## AIRWORTHINESS ADVICE NOTICE

**TYPE AFFECTED:** SZD-51-1 JUNIOR

**SUBJECT:** Miscellaneous reported defects and airworthiness information.

FIGURE 1.

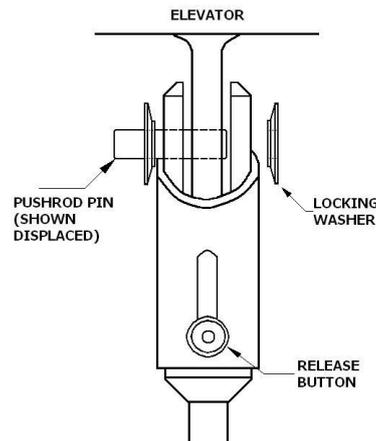
2. Experience has shown that the locking washer on the connecting pin in the elevator connector may work loose allowing the control to be connected incorrectly as shown in Fig 1.

Should the locking washer be loose then the defect must be rectified before the next flight.

The defect may be rectified by either replacing the washer (the best option) or by cold forming the washer until the hole is between 5.980 & 5.990 mm diameter.

Cold forming should be carried out by either pressing the washer between flat plates or by placing a steel ball (approx 20 mm dia) on the hole and then tapping with a hammer. If using the steel ball method the washer should be turned over and the process repeated.

Before pressing the washer onto the pin, the pin diameter should be checked for correct sizing:- 5.992 to 6.000 mm dia.
